TJERNLUND PRODUCTS, INC.

IMPORTANT!!! UC1 BOARD VERSION X.06 UPDATES

NEW X.06 VERSION UC1 BOARD FEATURES

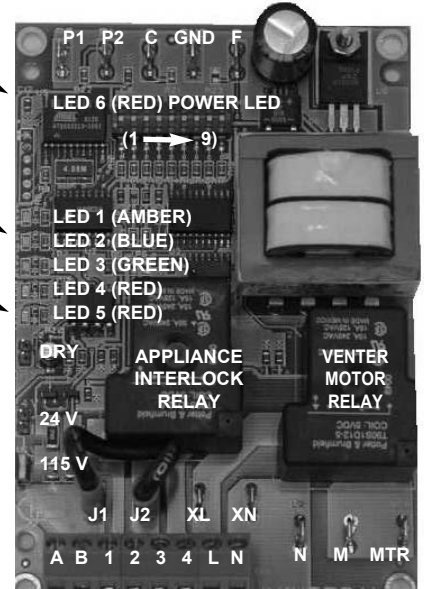
New LED # 6 RED
115V power supplied
to UC1 L & N terminals

LED # 2 now BLUE
(previously GREEN)

LED # 5 RED With no
call for heat, flashes 3
seconds on / 3 seconds
off if microcontroller is
working properly.

A new #6 power LED

Constant red when 115 VAC is supplied to L & N.

A new color for the #2 LED

Constant blue when fan prover safety circuit is closed.

A revised #5 LED

With no call for heat present, flashes 3 seconds on / 3 seconds off if microcontroller is working properly.
